November 17, 2009

Re: Dayton FG Battery
2RP-352
30-015-21733
Section 28, T18S-R26E
Eddy County, New Mexico

Dayton FG Battery Work Plan

SAMPLE DIAGRAM (Not to Scale)
Xenco Laboratories: #350003
Report Date: 11/6/2009
Xenco Laboratories: #351228
Report Date: 11/12/2009
Prepared by Robert Asher
Environmental Regulatory Agent

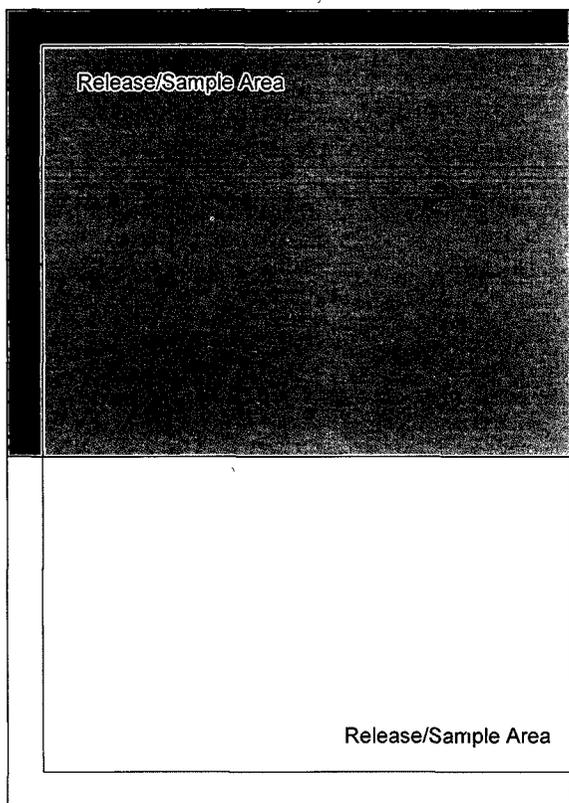
Currently two sample areas, GS/Comp-010 & GS/Comp-015 are above the RRAL's for the site ranking, the DRO levels are 1290ppm and 1310 ppm, DRO Hydrocarbons are not mobile and Yates would request that those impacted soils be left in place and upon approval of this work plan, Yates Petroleum Corporation will have a contractor use clean back fill material until the excavation is filled to current grade of battery. A 20 mil liner will be installed and a secondary berm would be built to provide containment of any future releases if a release occurs. When work is completed a Final Report, C-141 will be submitted requesting closure of the site.

⊗ Remove to 10'
MSB

As agreed, thanks Bob.

Per our conversation today, November 17, 2009, on the work plan submitted for the Dayton FG Battery, Yates will have a contractor excavate an additional two (2) feet of impacted soils on the north half of the current excavation (to a total depth of 10'). Impacted soils will be taken to an NMOCD approved facility. When soils have been removed the scope of work described in the work plan will be started.
